JRPP No:	2010SYE011
DA No:	DA10/0076
PROPOSED DEVELOPMENT:	Demolition of existing residential flat building and construction of a new residential flat building with strata subdivision 12 Ozone Street, Cronulla - Lots 1-11, SP 831 & Lots 12-13, SP 66933
APPLICANT:	Presflow Pty Ltd
REPORT BY:	Carolyn Howell, Assessment Officer Planner Sutherland Shire Council (02) 9710 0841

Supplementary Assessment Report and Recommendation

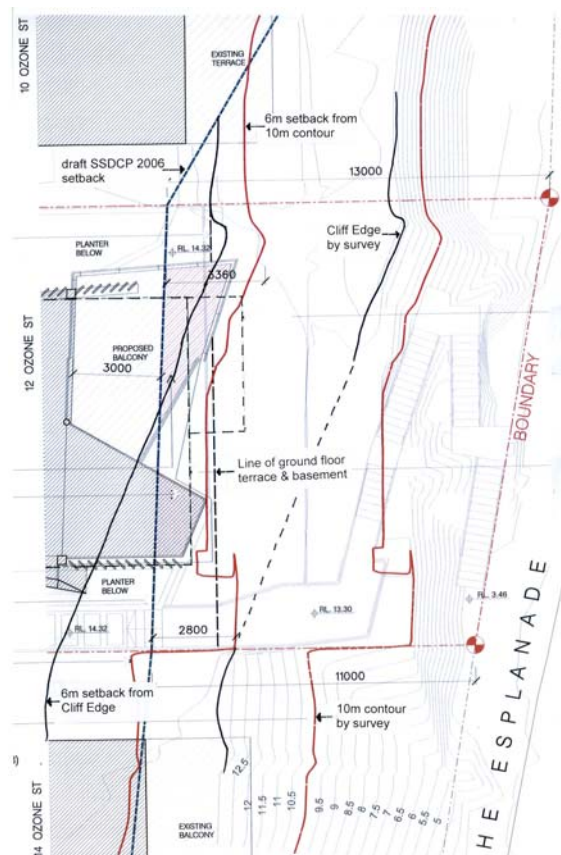
In the previous scheme the elevations showed that an extensive portion of the basement car park would be exposed and it was proposed to deal with this via sandstone cladding. In the current scheme the treatment of the cliff is unclear however it appears that the applicant is proposing to fill in part against the basement car park. The notation on the sections (DA-1006, DA-1401) and elevations (DA-1302, DA-1303) refers to the “proposed line of cliff face”. “Proposed” implies that it will be something that is constructed rather than something that is “existing” or “assumed to be existing”.

From the elevations and sections it is evident that portions of the cliff will be reconstructed as the “proposed line of cliff face” is located above existing structures and therefore must be reconstructed. The reconstruction of the cliff face is considered to be undesirable from a heritage perspective as the *Burra Charter* states the new work should readily be identifiable as such (article 22.2).

1. Cliff Face - Basement

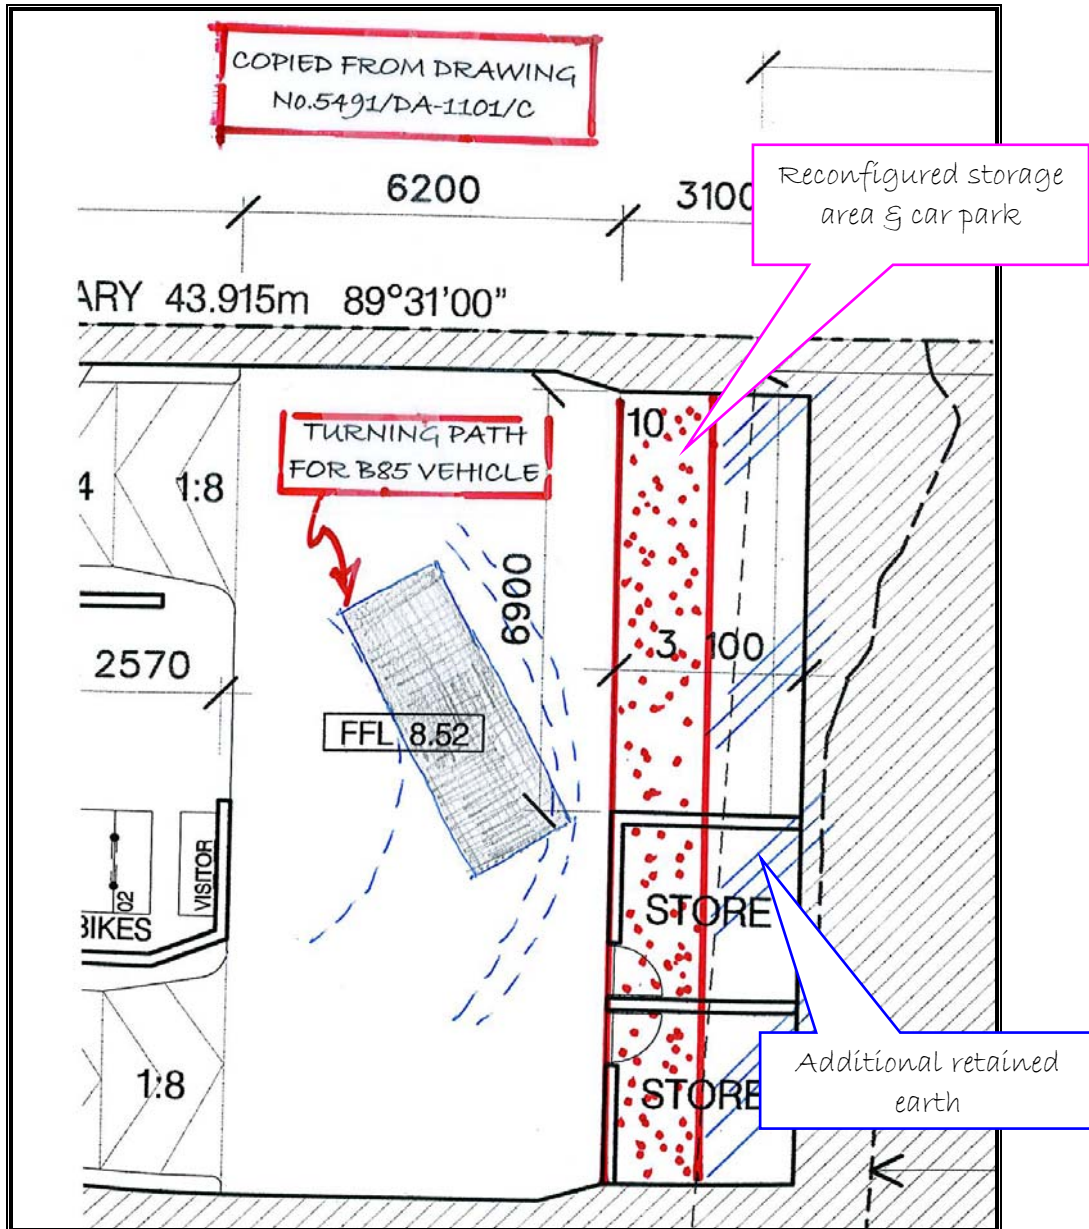
- i) The revised basement layout is an improvement as the outer eastern wall is located further away from the theoretical face of the heritage listed cliff, and
- ii) If car park bays 5, 10 & 12 were removed and the storage areas reconfigured as indicated on the following sketch, the volume of retained soil would significantly reduce the risk and would be supportable, provided suitable supervision is on hand at all times
